**Case File Number: PLN22006**

**October 26, 2022**

<b>Location:</b>	<b>1919 Webster Street</b>
<b>Assessor's Parcel Number(s):</b>	<b>008 063700808</b>
<b>Proposal:</b>	Major Conditional Use Permit for Large-Scale Development on a corner lot by demolishing an existing commercial building and surface parking lot in order to construct a 17-story, 269.8-foot-high office tower with a basement level parking garage. The project includes three Minor Variances for tower lot coverage, off-street loading, and bicycle parking.
<b>Applicant:</b>	1919 Webster Street Owner, LLC
<b>Contact Person/ Phone Number:</b>	Matt Weber, Ellis Partners/(415) 391-9800
<b>Owner:</b>	1919 Webster Street Owner, LLC
<b>Case File Number:</b>	PLN22006, PLN22006-ER01
<b>Planning Permits Required:</b>	Major Conditional Use Permit for Large-Scale Development; two Minor Conditional Use Permits for Administrative Commercial Activities at the ground floor and within 30 feet from any street-abutting property line; Minor Variances for tower lot coverage, off-street loading, and bicycle parking; Regular Design Review; and a Tentative Parcel Map to merge two lots into one lot (VTPM11233).

## CITY OF OAKLAND PLANNING COM

**SOUTH ELEVATION**

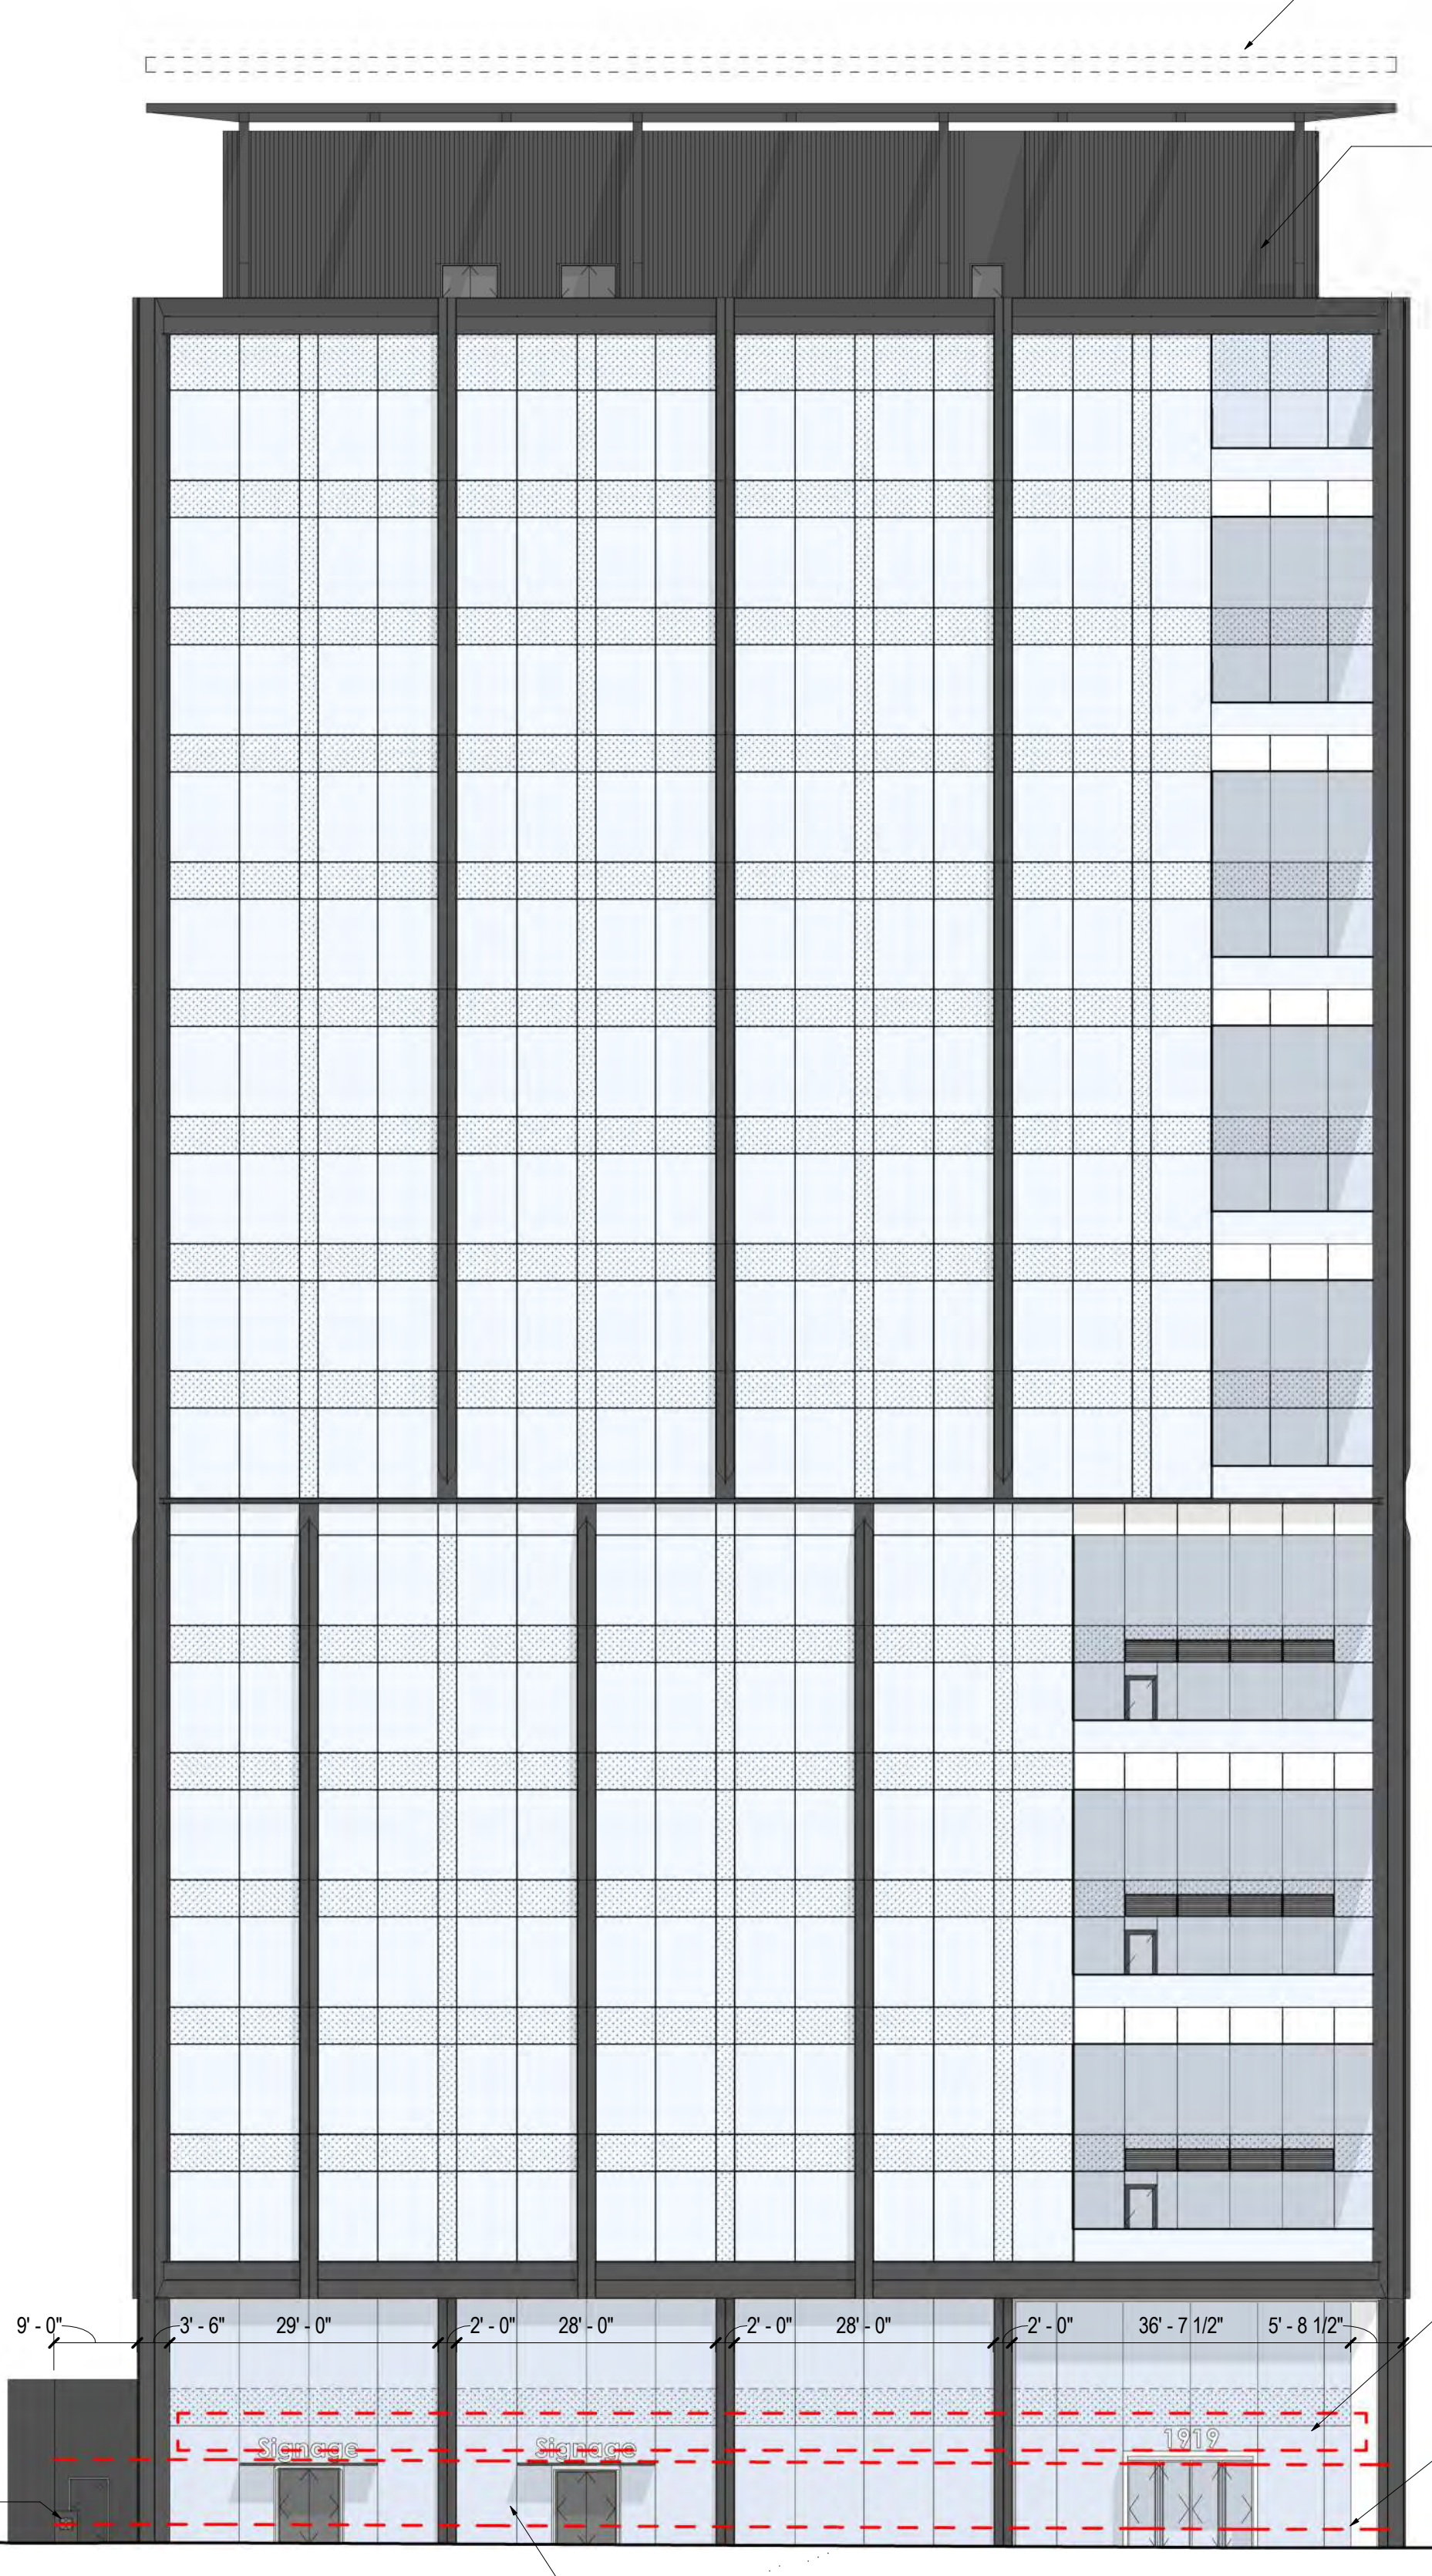
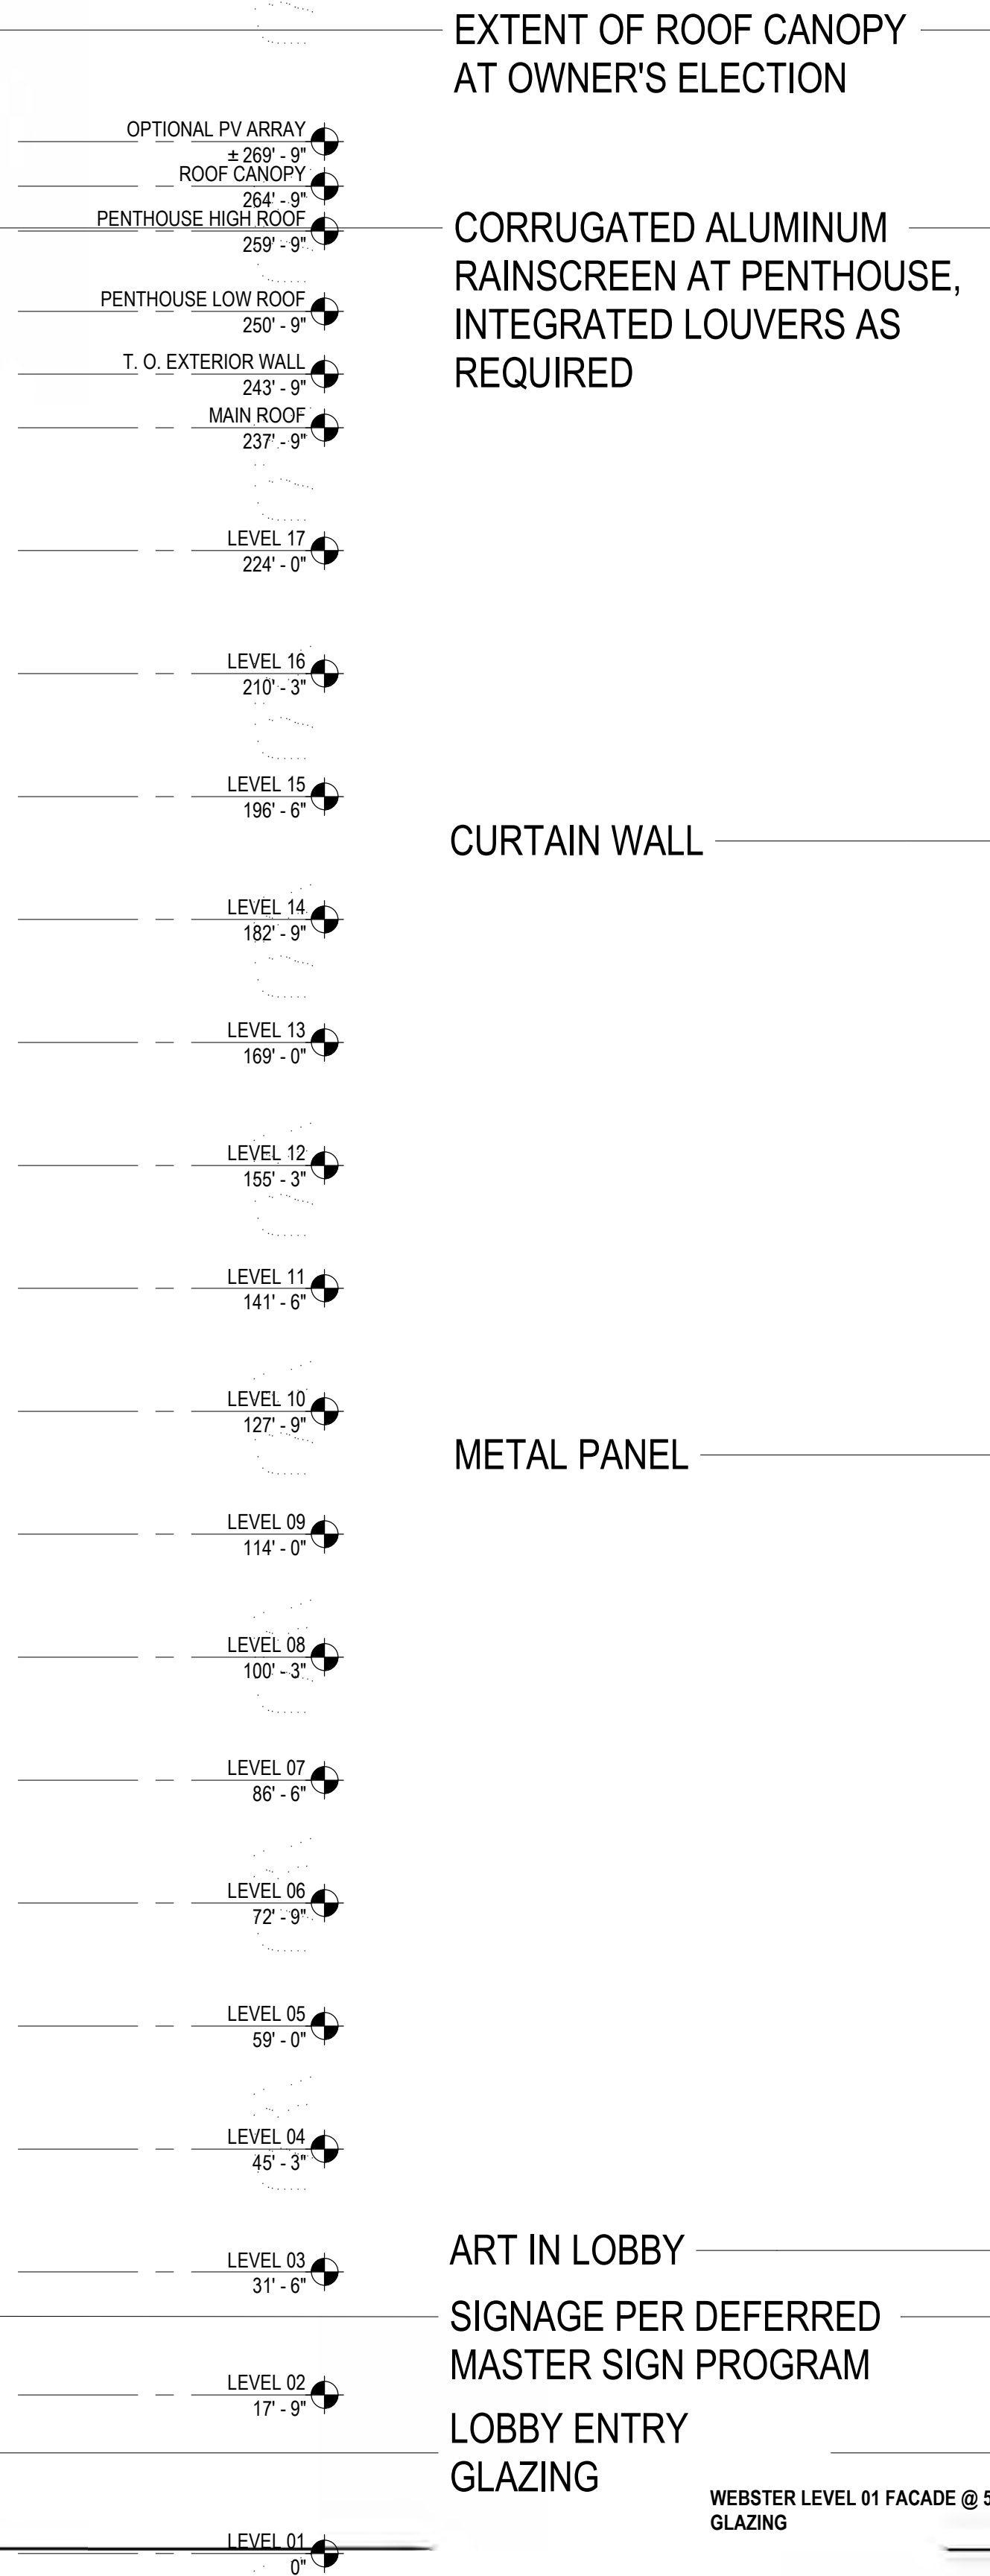
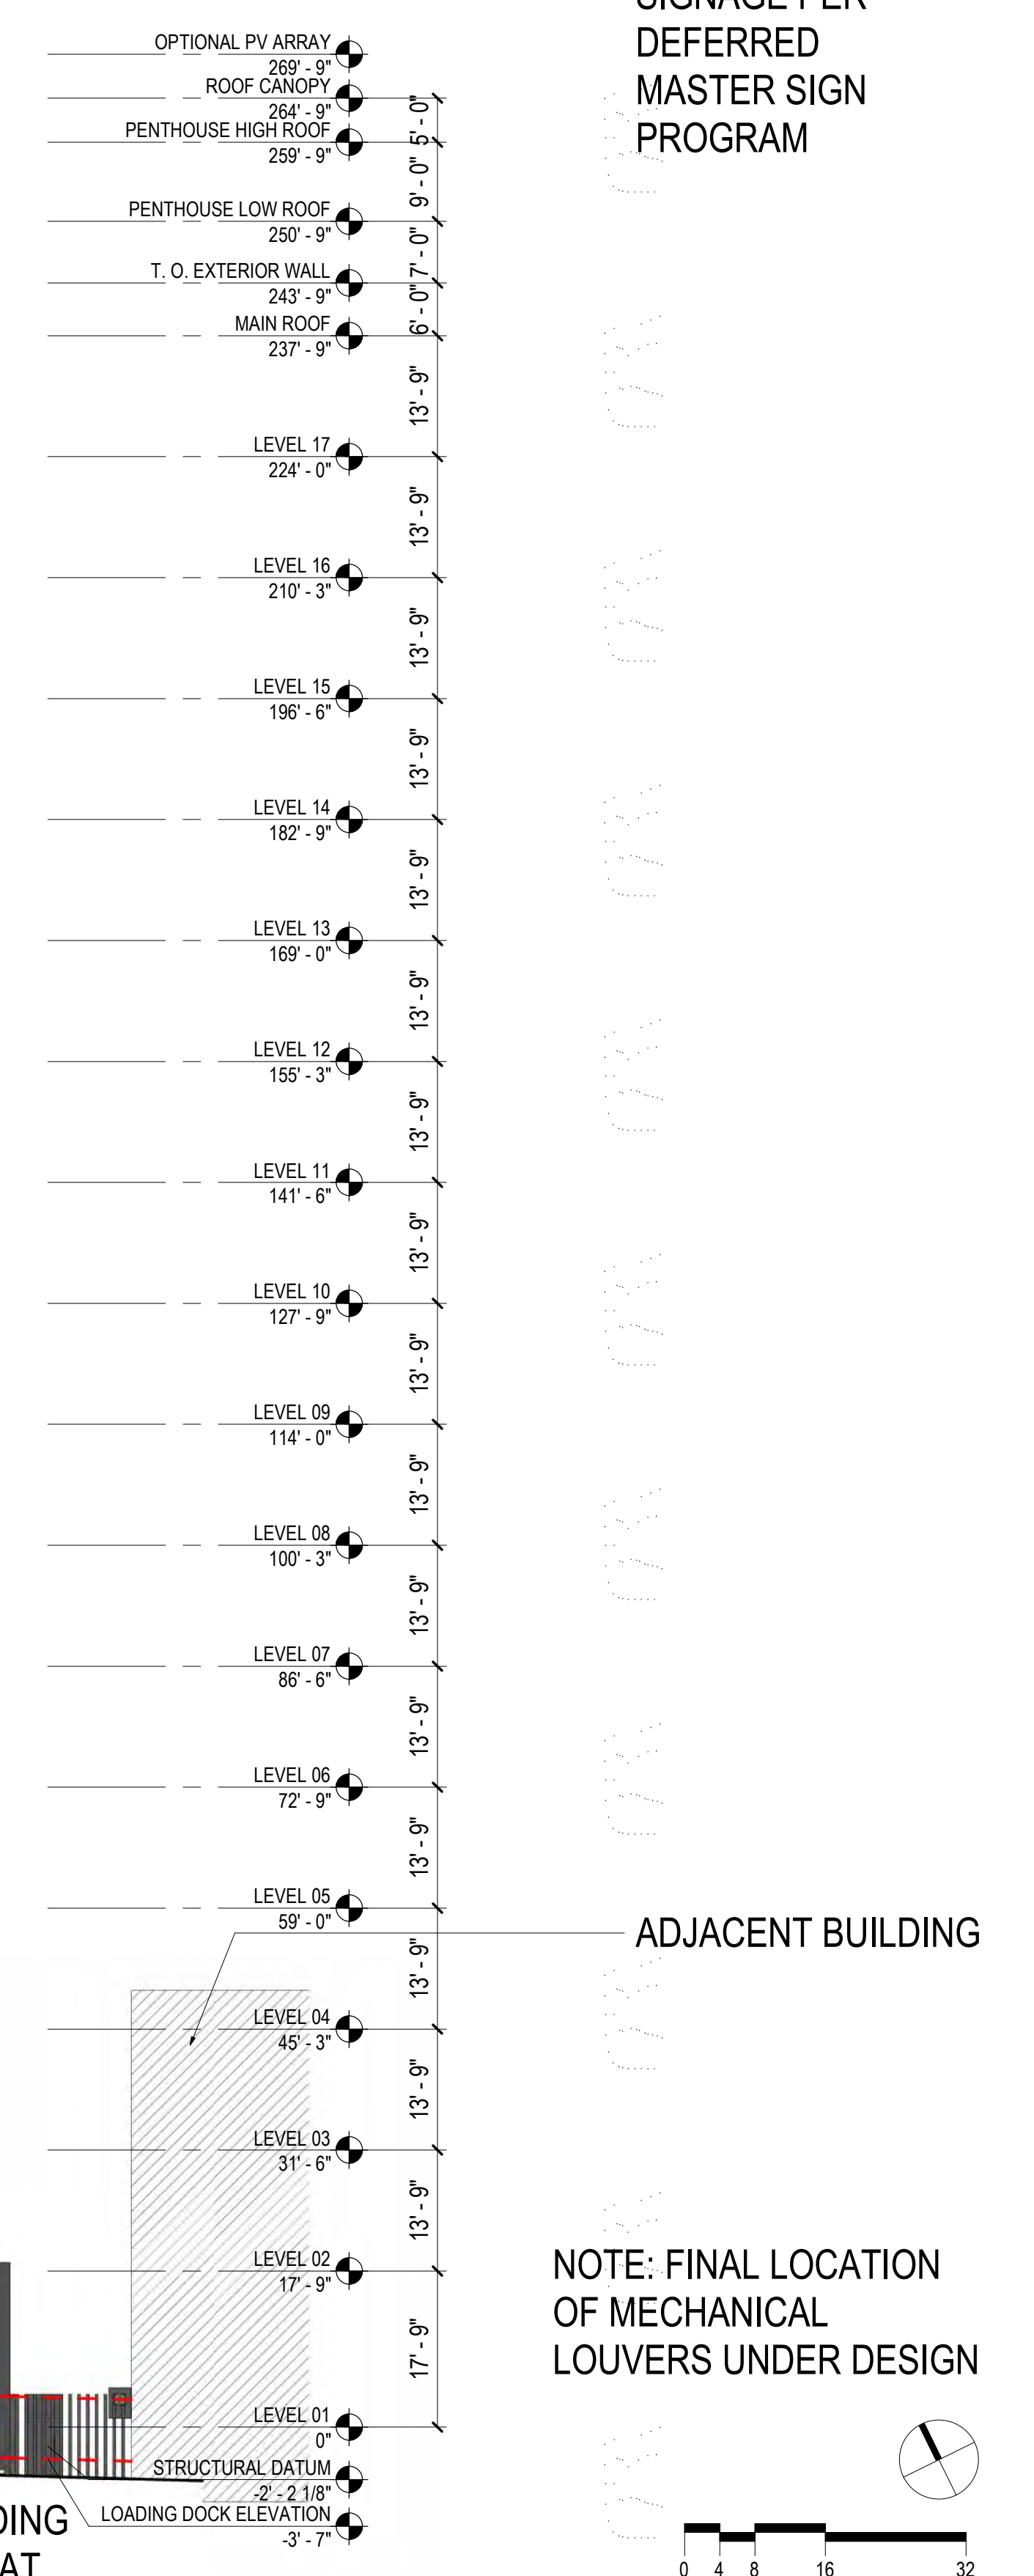
- **Entrance.** The renderings, material photos and floor plans show a short projection above the recessed lobby doors which are not clearly labeled in terms of the extent of the projection in the door area, change in materials, and additional detailing such as an awning or other features. Neither door exerts much prominence in comparison to the doors shown for the retail spaces on 19th Street.
  - *Does the DRC think the entrances should be enhanced additional detailing, more overhead projection and/or room for pedestrians to transition from the building interior to the streetscape?*
- **Ground Floor Treatment.** One color change, from brushed light gray metal to dark metal is the only exterior material listed for the ground floor design which is different

- from the tower materials. The retail space doors will open and encroach on the public right-of-way by about three and a half feet. Also, there only two street trees proposed for 19<sup>th</sup> Street and no street trees shown for Webster Street on the landscape site plans (Attachment A, page 35, Sheet L1.01.2). The design does not adequately show how the pedestrian experience would be enhanced.

- *Does the DRC think the proposed design should be revised to show how the design enhances the visual experience and is distinguished from the upper stories?*

- **Massing.** The box-like shape of the building exaggerates the mass and scale of the building. The lack of detail on the façade such as dimensions for projection or recesses, or lack of a distinct middle to the building creates a bulky and boxy building with a looming visual impact. There is little contrast, sculpting or articulation of the building from the base leading to the terminus which does not adequately differentiate between base, middle and top of the building. Also, as stated above, the applicant has revised the recessing and emphasis of the balconies' dimensions, but the focus of articulation and projection remains mostly on the building corner.

- *Does the DRC think the proposed design should be revised to refine the exterior and reduce the impression of a massive, boxy tower?*
  - **Building Terminus.** The roof features a penthouse structure storing mechanical and electrical equipment, the elevator run, and a partially visible canopy overhang. The applicant proposes two options for the roof top treatment and neither provides a distinct visual terminus.

- *Does the DRC think that by using architectural features such as curvilinear or stepped forms to soften the truncated tops of buildings, or by adding cornices or other architectural forms would help achieve a more distinct visual terminus?*
